CITY OF PORTLAND, OREGON

Staff Presentation to the Portland Design Commission

Land Use Review Hearing LU 15-259840 DZM BURNSIDE DELTA

> April 14, 2016 DR#1: February 4, 2016 DAR: September 10, 2015

PRIMARY CLADDING MATERIAL (please refer to sample)

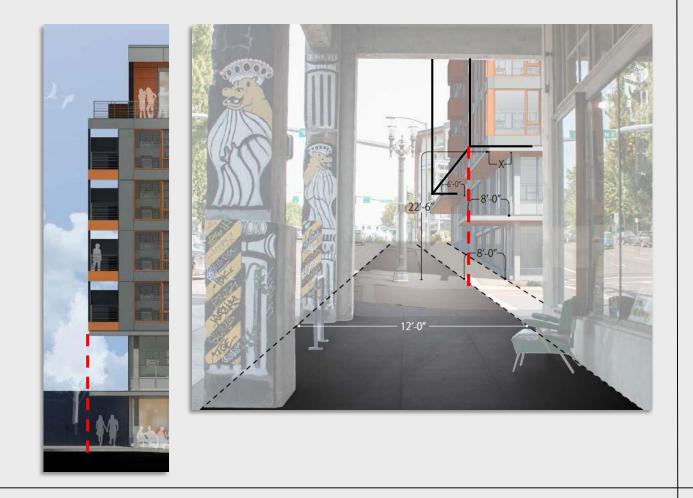
Replace Tread Plate Metal with (Taktil) Concrete Panel – blind fastened.

Staff Supports as meeting guidelines for quality and permanence C2 Quality & Permanence and C5 Coherency.

ARCADE + ENCROACHMENTS (please refer to handouts)

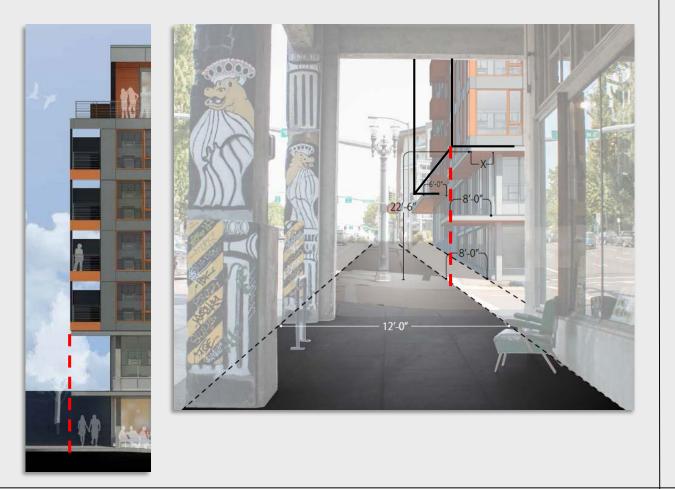
Staff Report Condition of Approval: The amount of building mass projection shall be a minimum of 8' along western most one-third of the E Burnside frontage (approximately 60').

Staff Supports as meeting guidelines A5-1 Arcades and C10 Encroachments.
